Form 3160-5
(June 2019)UNITED STATES
DEPARTMENT OF THE INTERIOR
BUREAU OF LAND MANAGEMENTFORM APPROVED
OMB No. 1004-0137
Expires: October 31, 2021**SUNDRY NOTICES AND REPORTS ON WELLS**
Do not use this form for proposals to drill or to re-enter an abandoned well. Use Form 3160-3 (APD) for such proposals.5. Lease Serial No. **NMNM77063**

Froderick 33 Fed Com 610H (FKA 586H) API #: 30-025-52161

EOG respectfully requests an amendment to our approved APD for this well to reflect the following changes:

**Froderick 33 Fed Com 610H****Revised Permit Information 09/22/2023:**

Surface Location

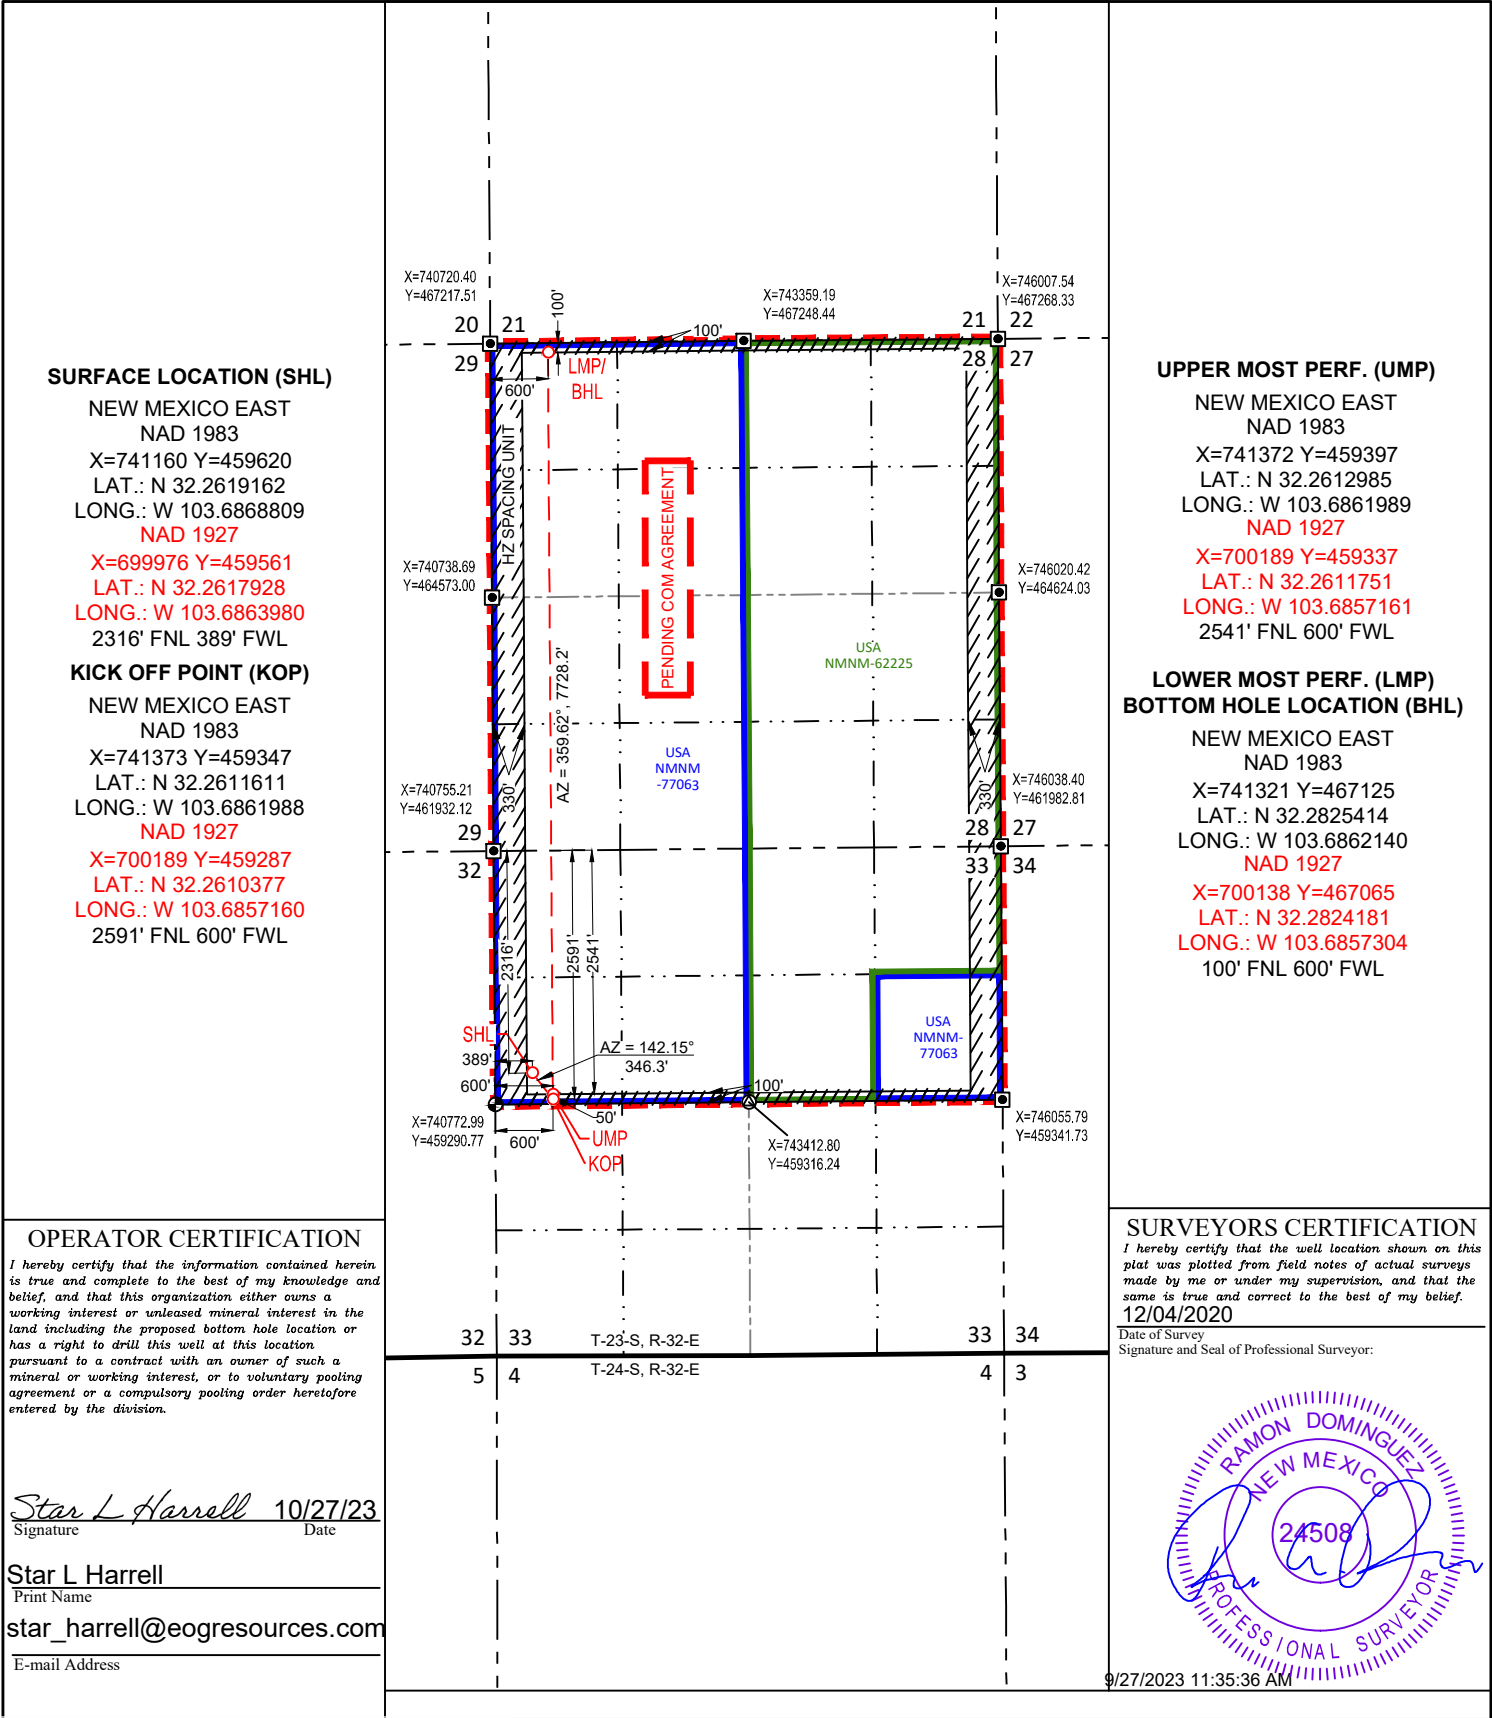
Change name from Froderick 33 Fed Com 586H to Froderick 33 Fed Com 610H.

Change BHL from T-23-S, R-32-E, Sec 28, 100' FNL, 330' FWL, Lea Co., NM, to T-23-S, R-32-E, Sec 28, 100' FNL, 600' FWL, Lea Co., N.M.

Update HSU to 960 acres.

UL or lot no. D	Section 28	Township 23-S	Range 32-E	Lot Idn -	Feet from the 100'	North/South line NORTH	Feet from the 600'	East/West line WEST	County LEA
--------------------	---------------	------------------	---------------	--------------	-----------------------	---------------------------	-----------------------	------------------------	---------------

Dedicated Acres 960.00	Joint or Infill	Consolidated Code	Order No. PENDING COM AGREEMENT
---------------------------	-----------------	-------------------	------------------------------------
